**PLANNING COMMISSION REPORT**  
**Regular Agenda — Public Hearing Item**

PC Staff Report  
4/23/14

**ITEM NO 9B: SPECIAL USE PERMIT; FAMILY FUN CENTER; W 24<sup>th</sup> Place and Inverness Drive (SLD/TLH)**

**SUP-13-00486:** Consider a Special Use Permit for Participant Sports & Recreation, Outdoor uses as part of a Family Fun Center, located at 4300 W 24<sup>th</sup> Place. The development includes a 20,000 square foot clubhouse and outdoor tot lot, batting cages, electric go-kart tracks and an 18-hole miniature golf course. Submitted by Paul Werner Architects, for Corporate Holdings II LLC, property owner of record. *Deferred by the Planning commission on 2/24/14.*

**Figure 2b. Family Fun Center parking lot- April Version**

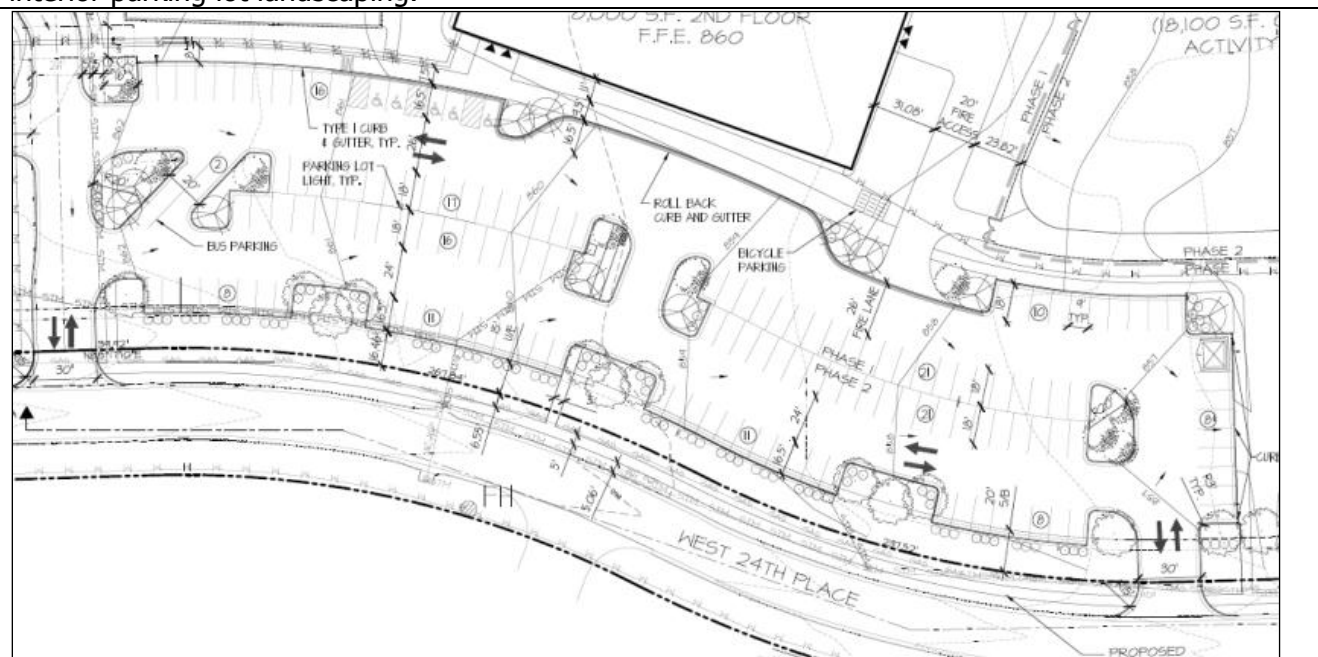
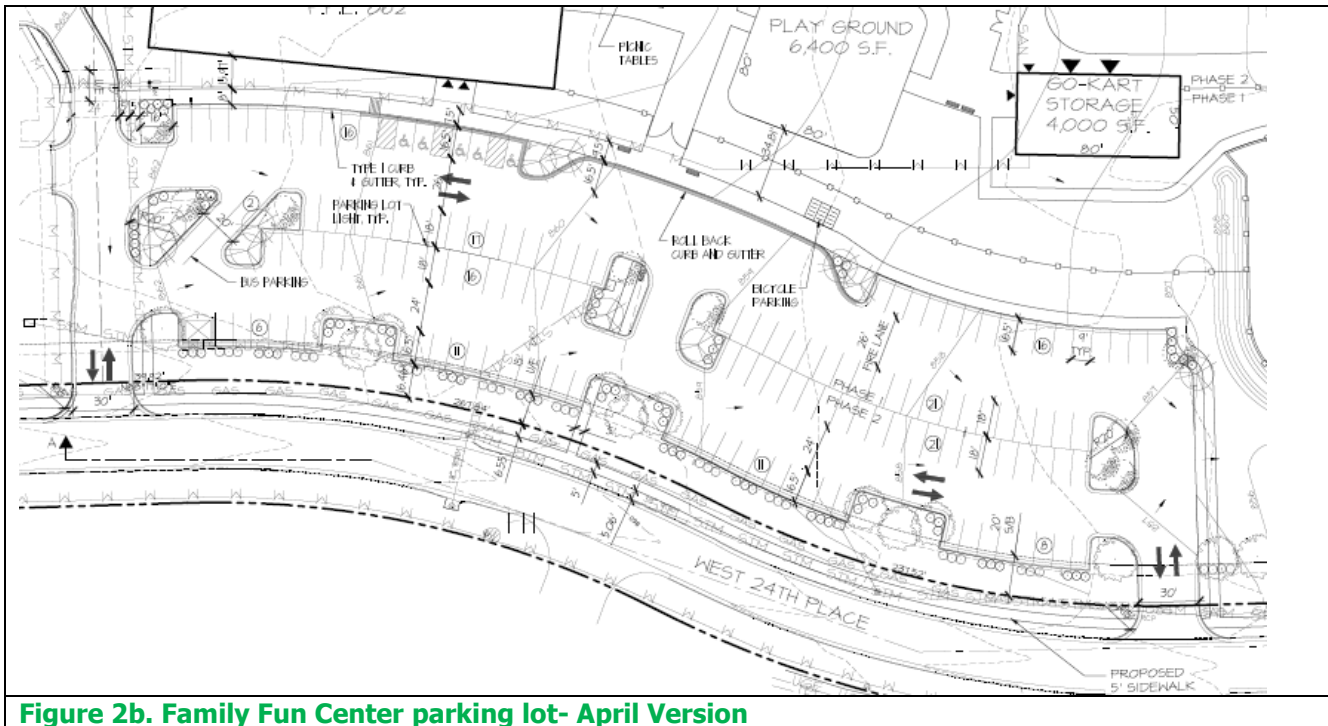
**Staff recommended the site be redesigned to provide an additional 5' along W. 24<sup>th</sup> Place to establish an area for the placement of the required street trees. The property is sufficiently large enough to accommodate this requirement and meet the subdivision and site plan requirements. This project represents greenfield development in that it is vacant unimproved land. There are no encumbrances to moving land uses to the north and providing a green space area along W 24<sup>th</sup> Street. The hardship to the applicant is the design time and effort that has implemented thus a with no regard to this comment provided during the review of the project.**

- a. Revise parking lot layout to include an additional 5' setback from W 24<sup>th</sup> Place to accommodate the installation of street trees along the perimeter;

**SITE PLAN**  
SCALE: 1" = 40'-0"

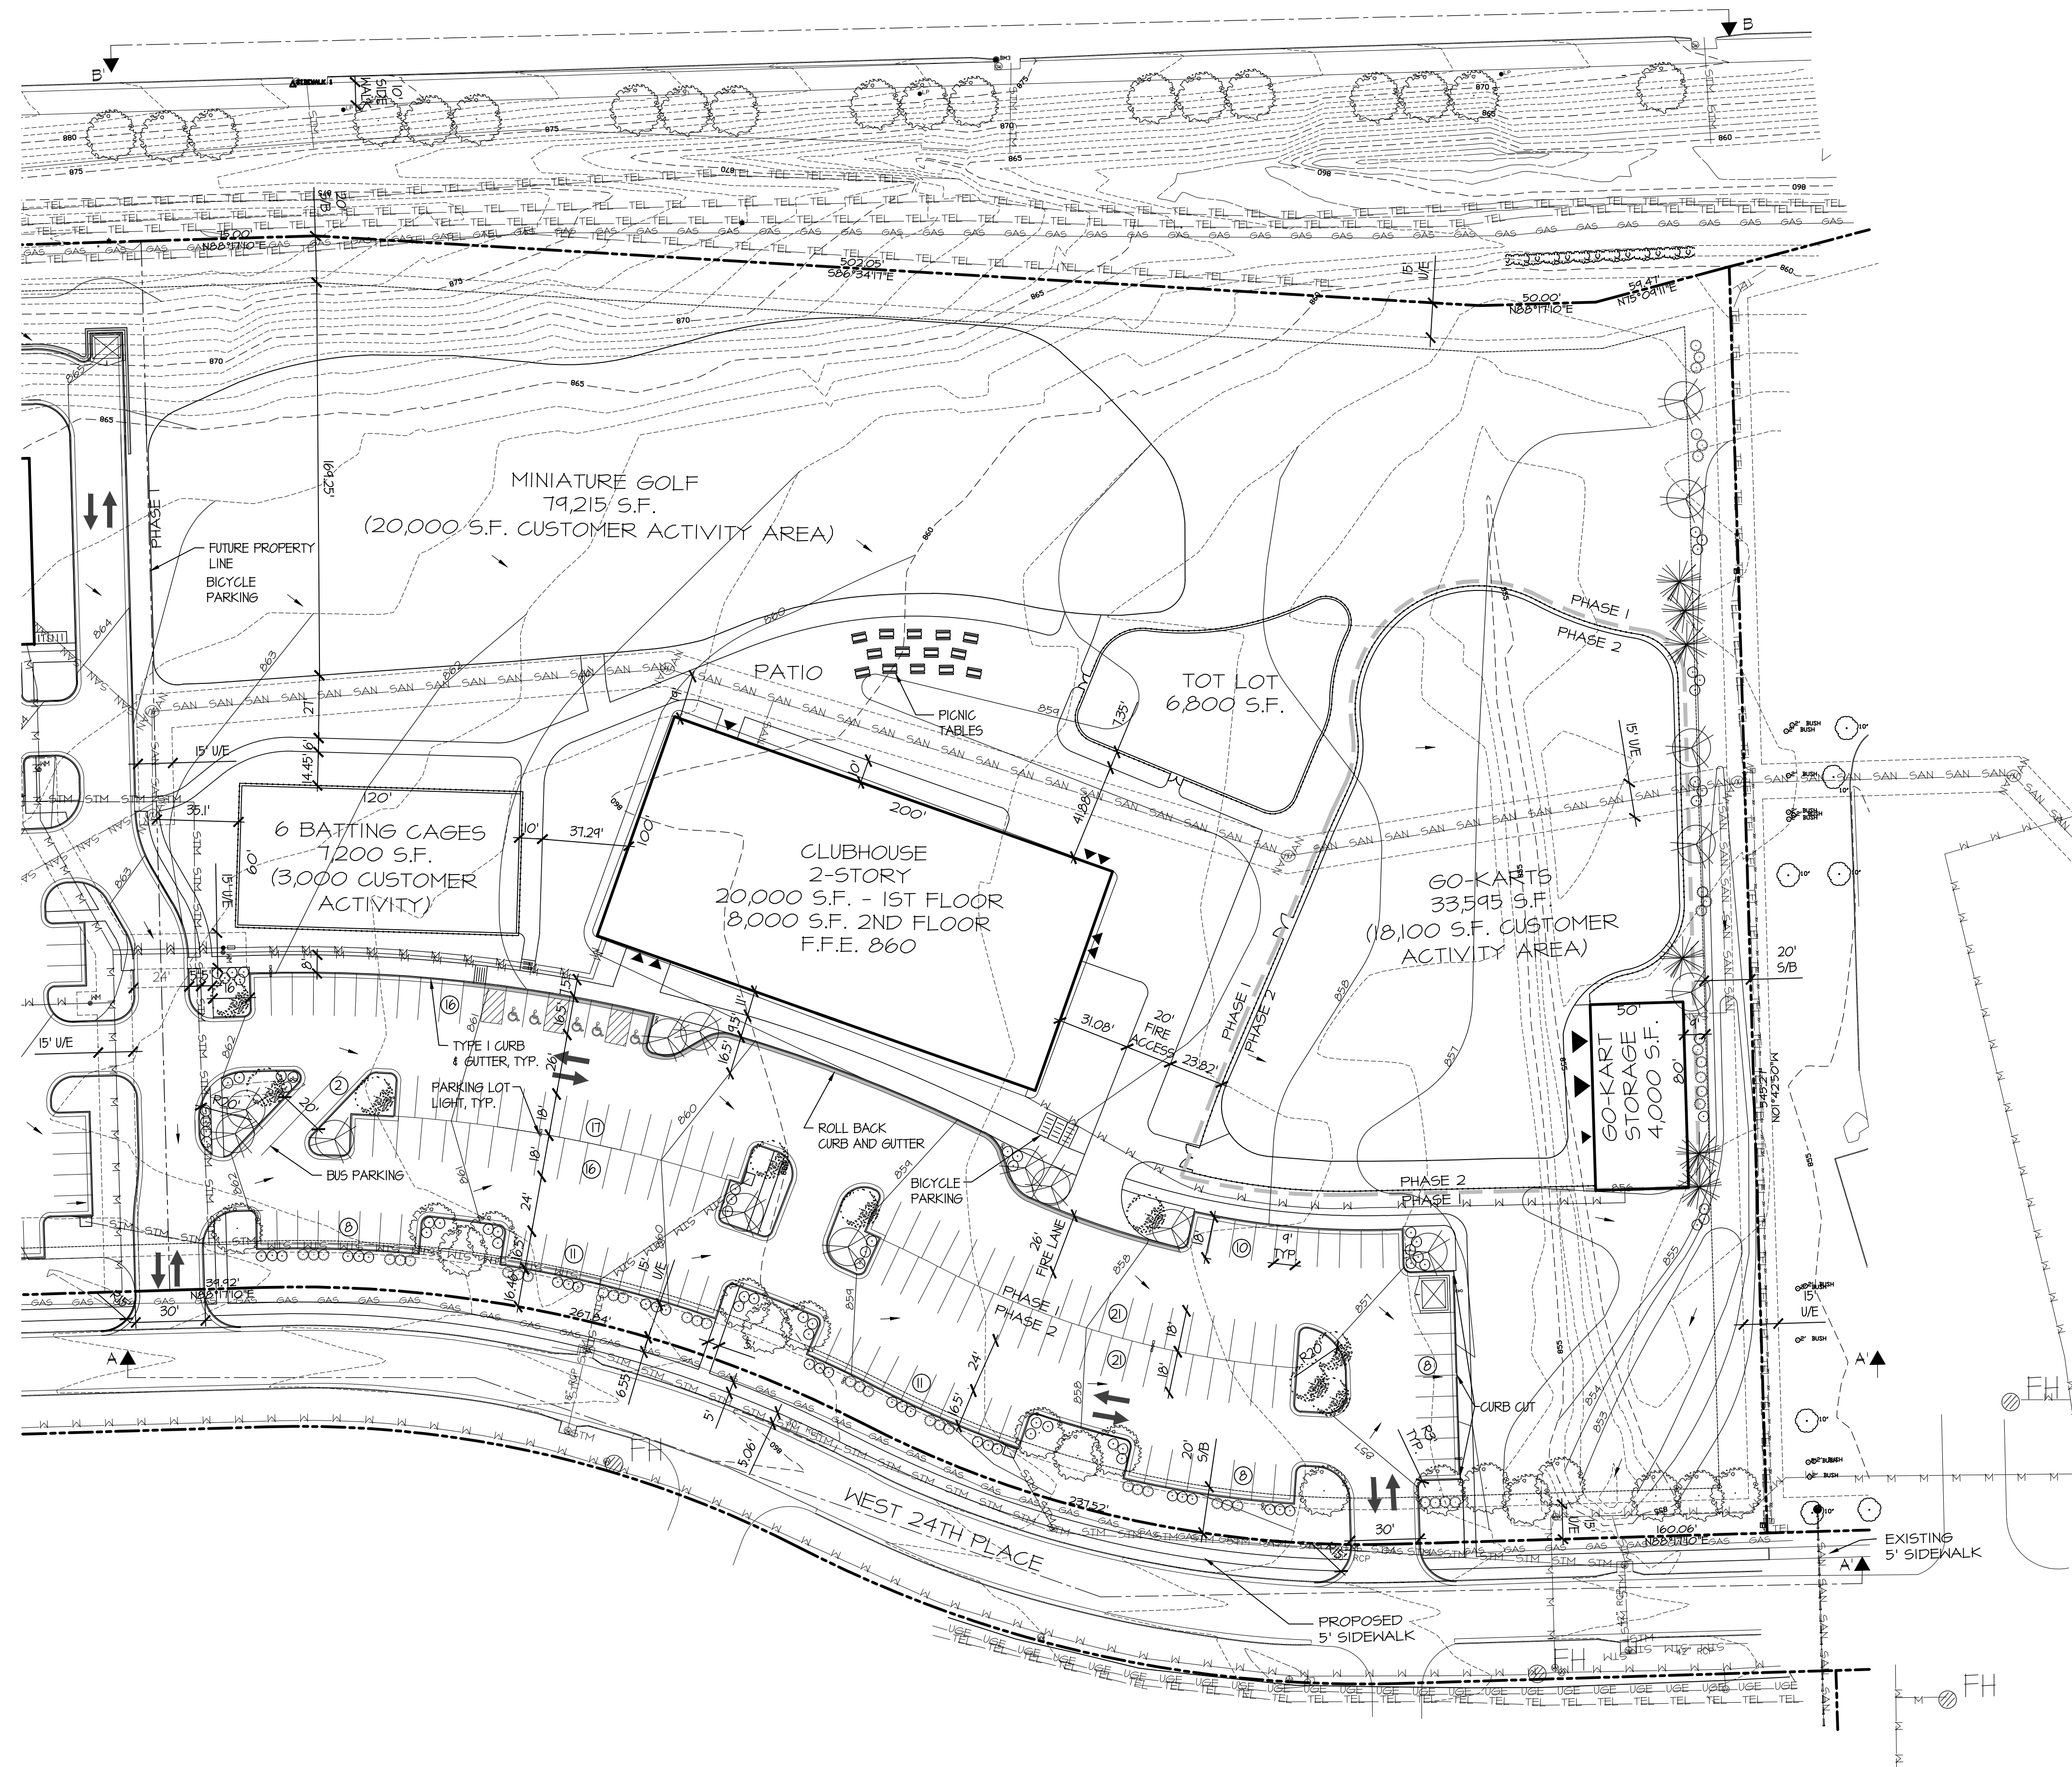
**This revised plan shows the proposed trash receptacle located along W 24<sup>th</sup> Place east of the shared entrance to the Family Fun Center and the future retail development. Staff recommend the trash receptacle be relocated to the north adjacent to the clubhouse. This will place the use closer to the clubhouse and provide a larger area to screen the trash receptacle within the site rather than along the public right-of-way.**

- viii. **Revise trash enclosure location, per City Staff approval, such as relocating trash enclosure to the north along the west side of the newly placed clubhouse.**
